CALIFORNIA COASTAL COMMISSION

STAFF REPORT: REVISED FINDINGS**REGULAR CALENDAR -- COASTAL DEVELOPMENT PERMIT *DE NOVO***

APPLICATION NO.: **A-1-MEN-01-043**

PROJECT DESCRIPTION: Construction of a 2,550-square-foot, 18-foot-high, single-family residence with a 625-square-foot detached garage, onsite sewage disposal system, extension of utilities, and installation of 2,500-square-feet of paving for a driveway.

CROSS SECTION A - A'
PROPOSED ROOST RESIDENCE
45501 Headlands Drive
Little River, California

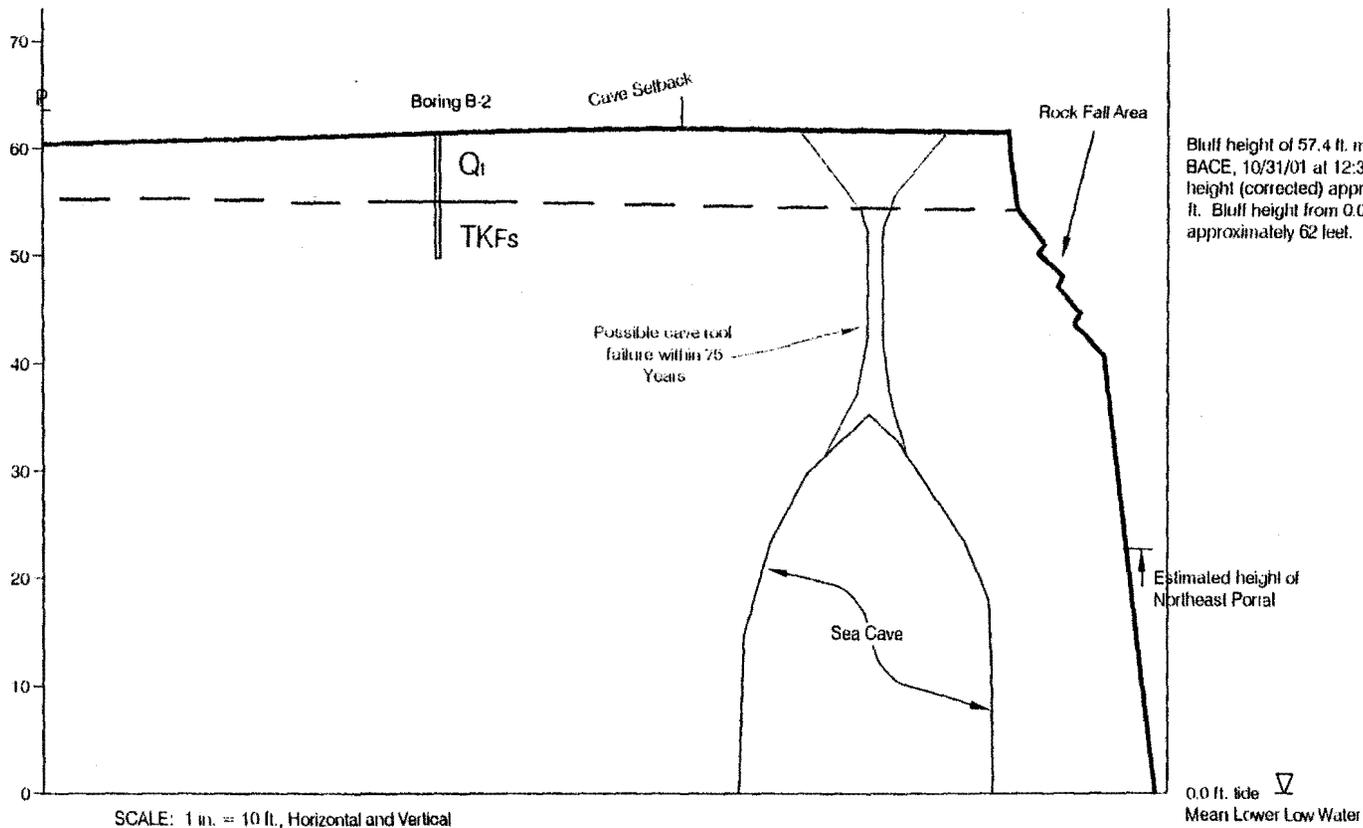
The Commission finds that the applicants' proposed 5-foot setback from the back of the sea cave to be inadequate and includes within Special Condition Nos. 1 and 2 requirements that a setback of 10 feet be provided between any structures and the blufftop projection of all underlying sea caves in addition to the required 25-foot-minimum setback from the existing bluff edge. The Commission finds that a setback larger than the 5-foot setback proposed by the applicants is necessary to find consistency with the policies of the LCP in that a proposed setback of only five feet would not provide an adequate buffer from bluff retreat should a portion of the sea caves collapse in the near future and the resulting bluff edge were to similarly retreat over the 75-year life of the structure at the one inch per year rate projected at the bluff face. A ten-foot setback would incorporate the approximately 6.25-foot setback the applicants' geologist identified would be necessary to deal with bluff retreat.

formed by erosion along an ancient, inactive fault trace. Since continued erosion along this fault trace could lead to partial roof collapse, possibly prior to 75 years from now, an additional cave setback of five feet from the cave wall, is recommended." The type of "partial roof collapse...prior to 75 years from now" that is envisioned by BACE is shown on modified Cross Section A-A', Plate 12, attached to this letter. Based upon this type of roof collapse, which could possibly occur within the next 50 to 75 years, a 5-foot setback from the cave wall, as recommended in BACE's report, should be adequate. Total roof collapse, as envisioned by Dr. Johnsson, could take an additional several hundred years.

- A setback of ten feet from the bluff top projection of the back of any sea cave wall underlying the site would incorporate the approximately 6.25-foot setback the applicants' geologist identified would be necessary to deal with the bluff retreat being similarly experienced along the open shoreline should sea cave collapse and subsequent bluff retreat threaten the structure during its 75-year expected life; and
- Ten feet is the minimum necessary to accommodate access by construction equipment around the perimeter of the structure should it become necessary to remove or relocate the house in the future if sea cave collapse and bluff retreat were to threaten the house during the 75-year life of the structure.
